**A57 Link Roads**

**TR010034**

**9.79 Applicant's comments on  
Deadline 8 submissions**

April 2022

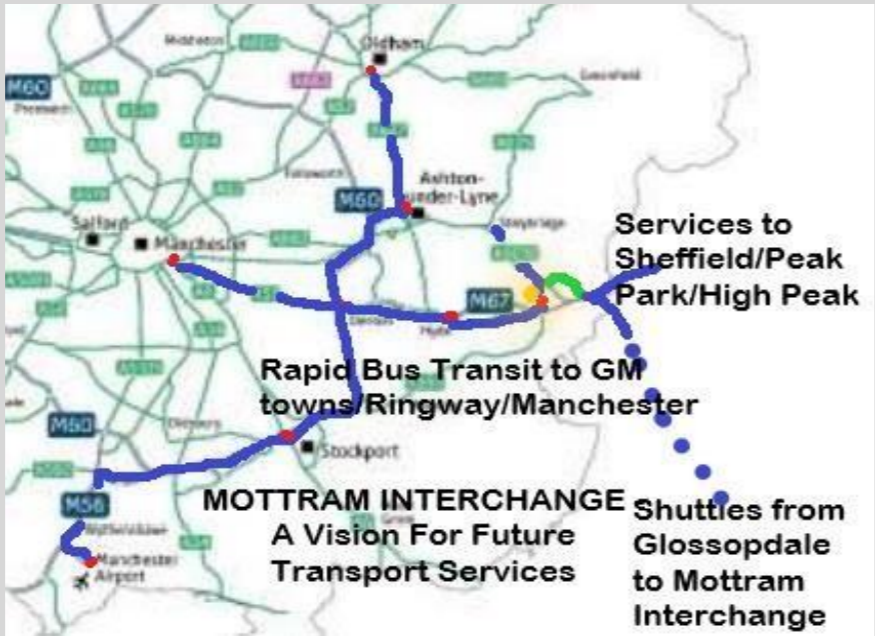
<p>9.79.94</p>	<p>Golden Opportunity versus Missed Opportunity</p> <p>For example, take the geographical position of the M67 terminus at Mottram. It is in an such an immensely strategic place that it could be considered to be a gateway to so many local and regional locations. It is on a perfect crossroads to deliver everything on the GMTS wish list and can provide solutions to most, if not all of the interested parties. (See also Diagram on page 10.)</p> <p>Given the assumption that the Mottram Gyratory Flow (MGF) as previously submitted (REP2 – 088), was in place, we already have, at very little cost and in very little time the free circulation of traffic due to the removal of the Mottram traffic lights and an improvement in air quality to boot. With so little money spent and so little land taken therein lies an opportunity to progress a potential Interchange that could be used as a launchpad to take passengers in all directions of the compass.</p> <p>For instance, frequent shuttles could ferry commuters from Glossopdale up the unblocked Moor to a single point where they could make their connection. From here they could access one-stop/limited stop services to their destination, with buses making rapid transits straight down the motorway via Denton onto Manchester, Stockport, Ashton, Oldham etc. The M67 M- way junction is already there, the infrastructure is already in place. We just need to get passengers to their point of embarkation and this is how it can be done.</p> <p>The Mottram Interchange (MI) could become the point of departure too for commuter services to Sheffield, for enabling trips into the Peak District National Park without the use of cars and/or to support tourism in High Peak. Mottram stands at a crossroads between Manchester and Sheffield, Tameside and the High Peak, so is thus a natural embarkation point for journeys in all directions.</p> <p>Once established as a point of connectivity, the MI creates a fascinating combination of possibilities for the future of public transport that would enable Tameside in particular to resolve its massive dependency on the car. The GMTS notes in its section on the borough</p>	<p>The alternatives to the proposed Scheme considered by National Highways and the justification for their rejection are set out in Chapter 3 of the Environmental Statement (APP-060) and item 9.75.34 in Applicant's written Summary of Issue Specific Hearing 3 (REP8-019).</p>
